Planning Commission

Regular Meeting Agenda

Frances Meaders Council Chambers
151 Willowbend Road
January 26, 2026 | 6:30 PM

CONCEPT PLAN FOR
 BRADSHAW ESTATES

DETAILED DIMENSIONS OF BRADSHAW ESTATES SOUTH LOTS 6-29
SCALE: 1"=100'

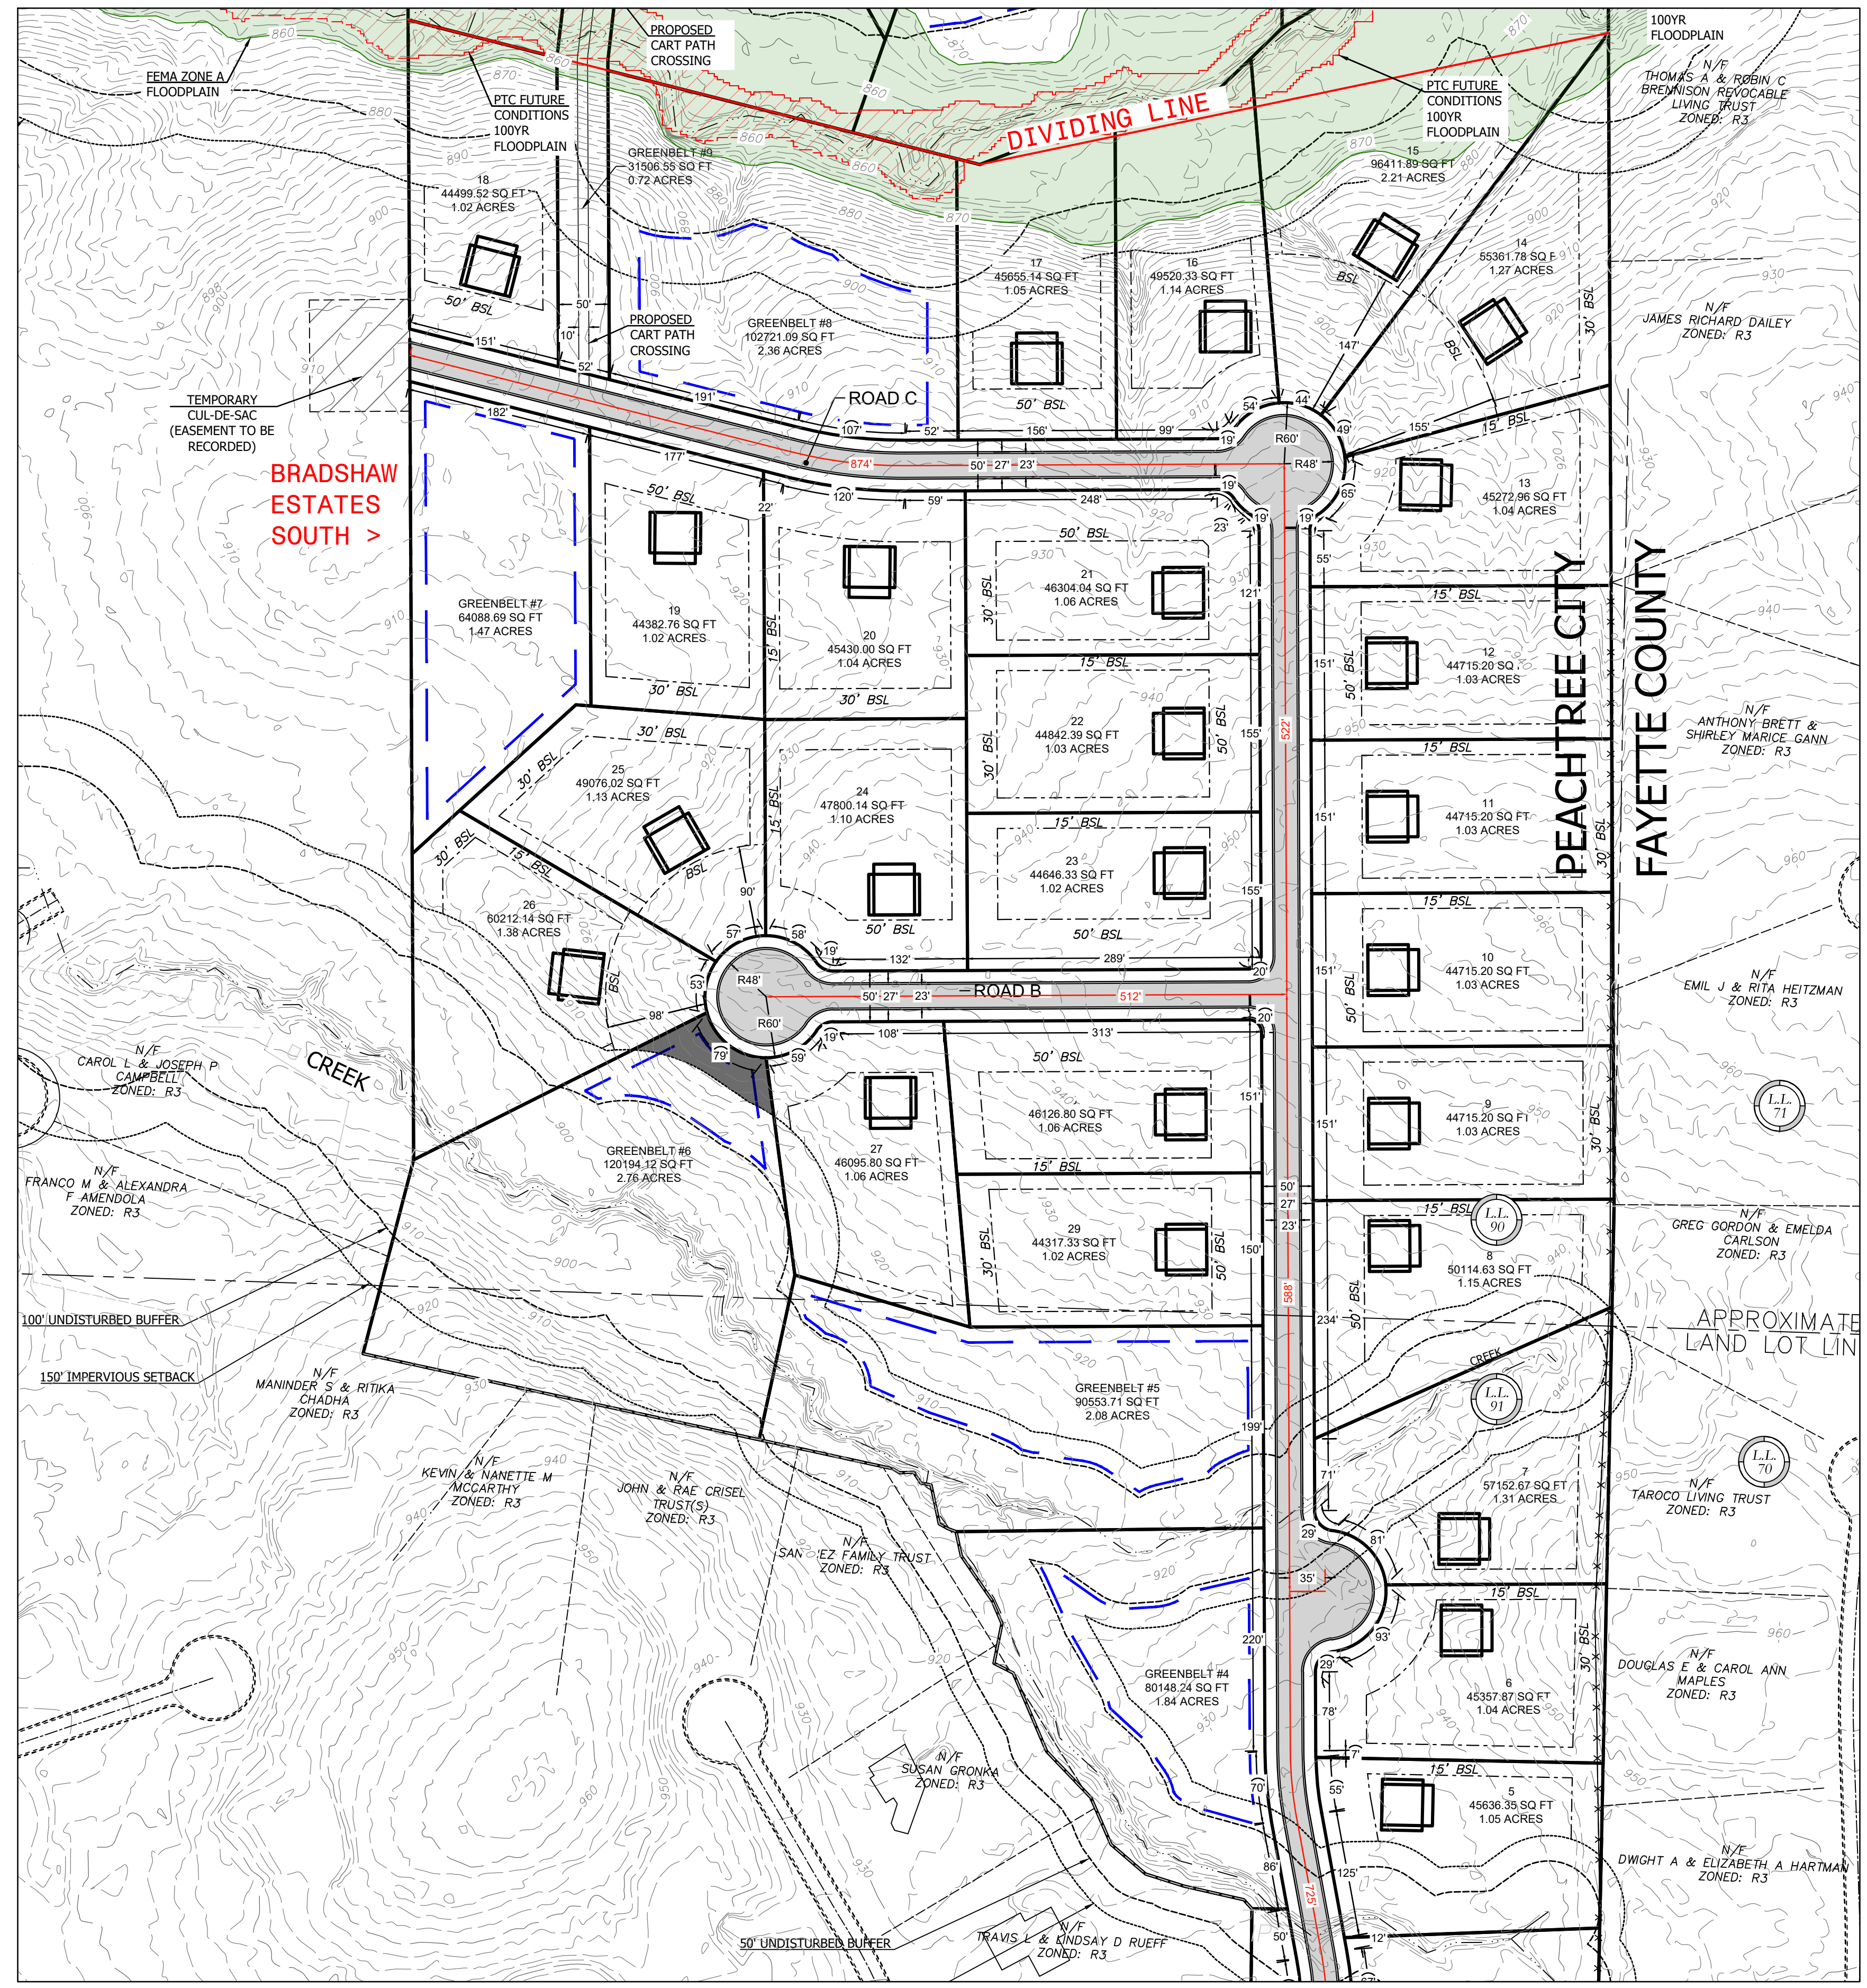
(DM comments) Lots 6, 7, and 8 will be exposed to erosion due to the water flow based on the terrain evaluation change from current yards of 120, 130, 140, and 150 Sedgewicke Drive. In addition, it is important to mention there are over 5 trees on top of my property at 150
